MM11

digital	FIELD SERVICE TECHNICAL MANUAL				Option or Designator
	12 Bit <input type="checkbox"/>	16 Bit <input checked="" type="checkbox"/>	18 Bit <input type="checkbox"/>	36 Bit <input type="checkbox"/>	MM11

digital		ENGINEERING CHANGE ORDER		ECO NO. MM11E-00017 Sheet 1 of 4
ORIGINATOR RICHARD MANION DATE 12/15/70	EXT. 2005	RECEIVED CHG. DATE 12/22/70	ISSUED ECO DATE 1-22-71	FINAL RELEASE DATE
				DISCRETE PROJECT NUMBER 11 07602
EQUIPMENT AFFECTED				
TYPE CHANGE		UNIT TO BE CHANGED	CHECKLIST	
ELECTRICAL <input checked="" type="checkbox"/>	MECHANICAL <input type="checkbox"/>	MM11-E	SHOP MODEL	YES NO <input type="checkbox"/> <input checked="" type="checkbox"/>
MODULE <input type="checkbox"/>	SUBASSEMBLY <input type="checkbox"/>	PRODUCT LINES	SYSTEMS PROGRAMS	<input type="checkbox"/> <input checked="" type="checkbox"/>
MFG/FIELD PROCEDURE <input type="checkbox"/>		PDP11	DIAGNOSTICS	<input type="checkbox"/> <input checked="" type="checkbox"/>
TEST INFORMATION			TECHNICAL PUB.	<input checked="" type="checkbox"/> <input type="checkbox"/>
SERIAL #			TEST PROGRAMS	<input type="checkbox"/> <input checked="" type="checkbox"/>

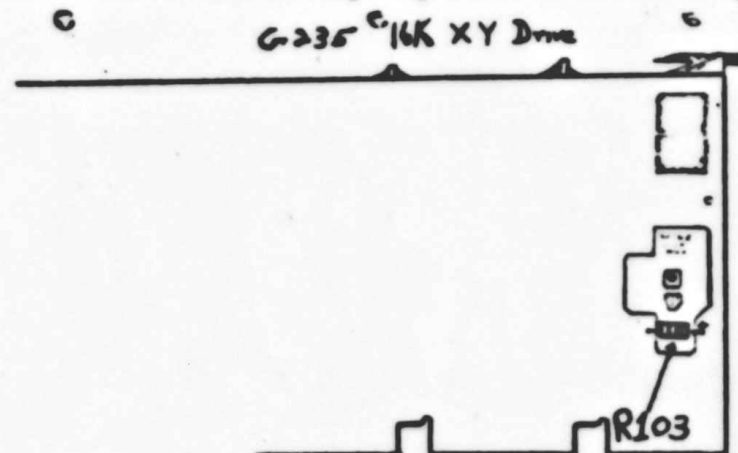
Many reports have been received from the field concerning memories failing high current margins and module set incompatibility (i.e. unable to swap modules). Investigation has shown that the inhibit margins are not properly centered, which could cause marginal operation of the memory under conditions of high drive currents. An ECO (G235-0009) was generated to correct this problem.

Therefore, if a memory exhibits these symptoms, do a visual inspection of the G235 for the ECO. A quick check for the ECO is:

1. Place G235 component side up and fingers toward you.
2. Look at right hand side of module in large etch area (see drawing).
3. If resistor R103 (75Ω 1W) which is across bottom of large etch is not in, ECO has not been installed.

This ECO should be installed before attempting massive module swap or option swap.

digital	CORP. MEMORY STACK (X DRIVE)		DWG NO. D-05-MM11E-03	REV B
	ENGINEERING CHANGE ORDER	URN <i>Ally...</i>		
	CHK'D <i>Cathy</i>	ENG. LOC.

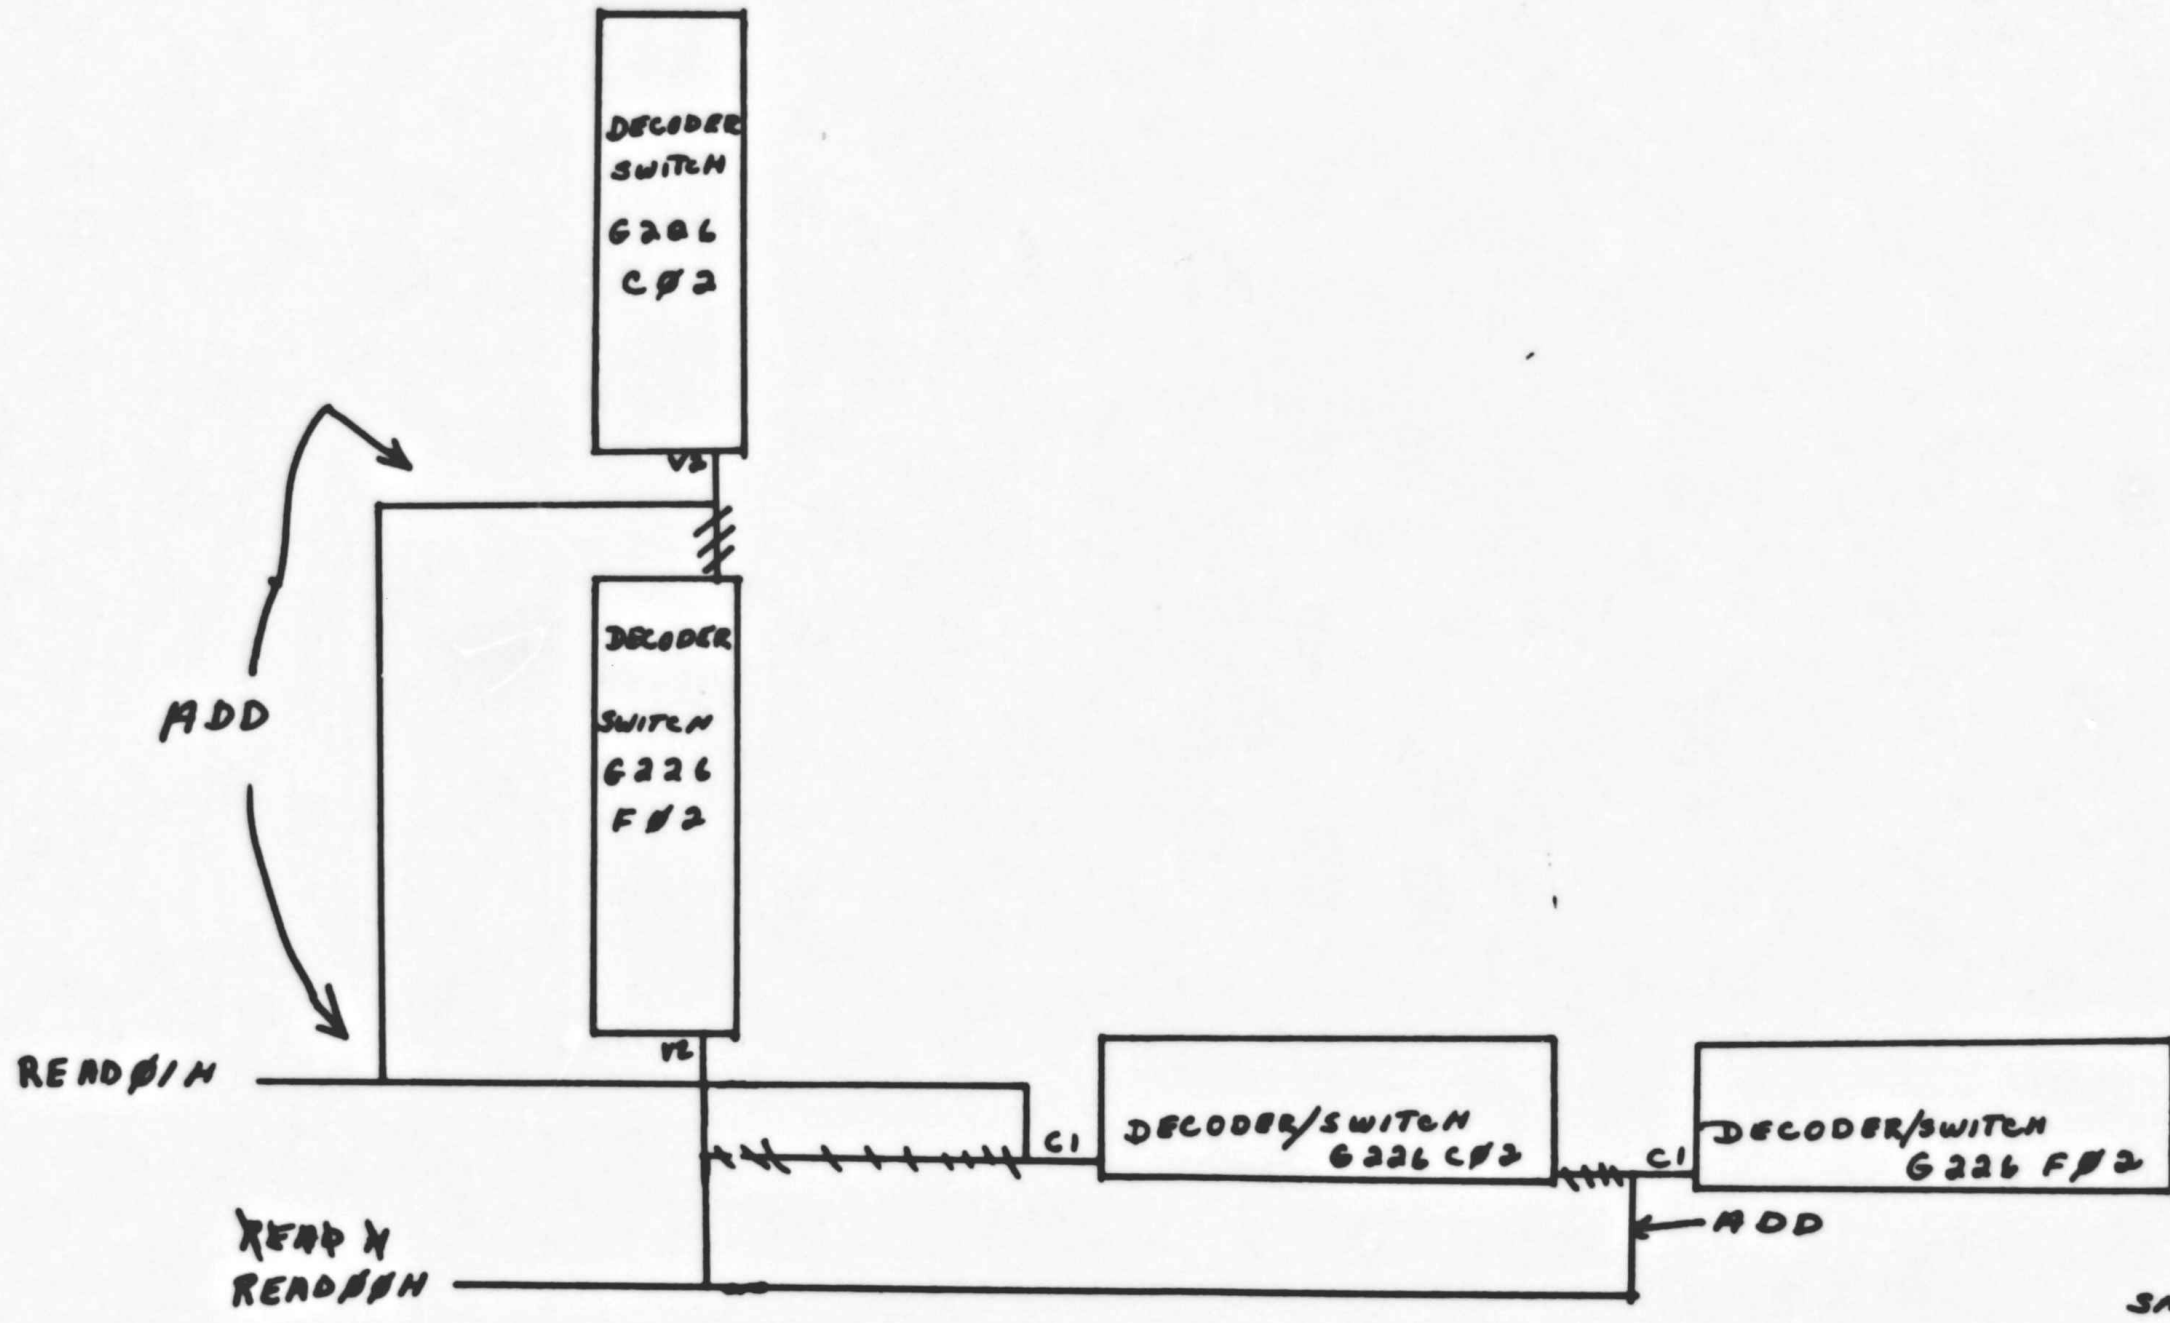
ITEM NO.	DOCUMENT/PART NO.	OLD REV	NEW REV	DISP CODE	DESCRIPTION OF CHANGE	DOCUMENTATION AFFECTED	FIELD SERVICE AFFECTED	TYPE OF CHANGE
1	K-WL-MM11-E-07	D	E	06	Wire List Update	<input type="checkbox"/> MODEL	<input checked="" type="checkbox"/> YES <input type="checkbox"/> NO	<input checked="" type="checkbox"/> ELECTRICAL
2	D-AD-7006468-0-0	D	E	06	Wire Ass'y MM11-E See final release print.	<input type="checkbox"/> DIAGNOSTICS	<input type="checkbox"/> Customer Charge	<input type="checkbox"/> MECHANICAL
3	D-BS-MM11-E-03	A	B	06	Core Memory stack (2 sheets) See final release print.	<input type="checkbox"/> TECH MANUAL	<input checked="" type="checkbox"/> Product Line Change	<input type="checkbox"/> MODULE
4	A-ML-MM11-E	Z	AA	06	UPDATE PRINT PER THIS E.C.O.	<input type="checkbox"/> TESTER		<input type="checkbox"/> ORDER PR MODEL
5	C-DI-MM11-E-01	E	F	06	UPDATE PRINT PER THIS E.C.O.	<input type="checkbox"/> TEST PROG		<input type="checkbox"/> YES

SIGNAL NAME	FROM PIN	TO PIN	COMPONENTS	ADD	DEL
READ H	C02V2	D01A1	REMARKS		X
READ 01 H	C01F2	C02C1		X	
STROBE 0 H	C01F1	D02S1			X
STROBE 01 H	C01A1	E02S1			X
TINH 0 H	D02E1	E01S1			X
TINH 1 H	E01H2	F01F1			X
STROBE 0 H	C01F1	D02S1	WHT	X	
GND	C01C2	D02T1	BLK	TWP	X
STROBE 01 H	C01A1	E02S1	WHT	X	
GND	C01C2	E03T1	BLK	TWP	X
T 0 INH	E01S1	D02E1	WHT	X	
GND	E01C2	D01C2	BLK	TWP	X
T 1 INH	E01H2	F01E1	WHT	X	
GND	E01C2	F01C2	BLK	TWP	X

ECO NO.
MM11F-00003
Sheet ___ of ___

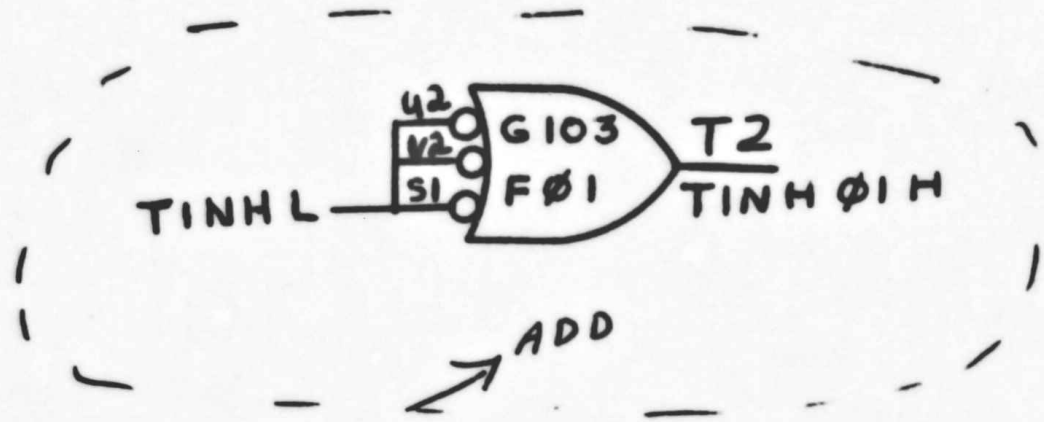
1. Strobe signals and TINH have too much noise on them.
2. Read H signal has too many loads on it.
3. Solves memory problems caused by DMA transfers that memory diagnostics don't show up, also, solves slot sensitive G103, G102 problems.

SIGNAL NAME	FROM PIN	TO PIN	COMPONENTS	ADD	DEL
TINH H	C01C1	D02E1			X
TINH H	D03E1	E03E1			X
TINH H	E01E1	F01E1			X
STROBE 0 H	C01R1	D02S1			X
STROBE 01 H	C01R1	E01S1			X
TSS H	F01V2	F01P1			X
TINH L	C01K1	F01S1		X	
TINH L	F01S1	F01U2		X	
TINH L	F01U2	F01V2		X	
TINH 0 H	C01C1	D02E1	WHT	TWP	X
GND	C01C2	D02C2	RED		X
TINH 01 H	F01T2	F01F1	WHT	TWP	X
GND	F01T1	F01C2	RED		X
TINH 01 H	F01T2	E02E1	WHT	TWP	X
GND	F01T1	E02C2	RED		X
STROBE 0 H	C01R1	D02S1	WHT	TWP	X
GND	C01T1	D02T1	RED		X
STROBE 01 H	C01R1	E01S1	WHT	TWP	X
GND	C01C2	E01T1	RED		X
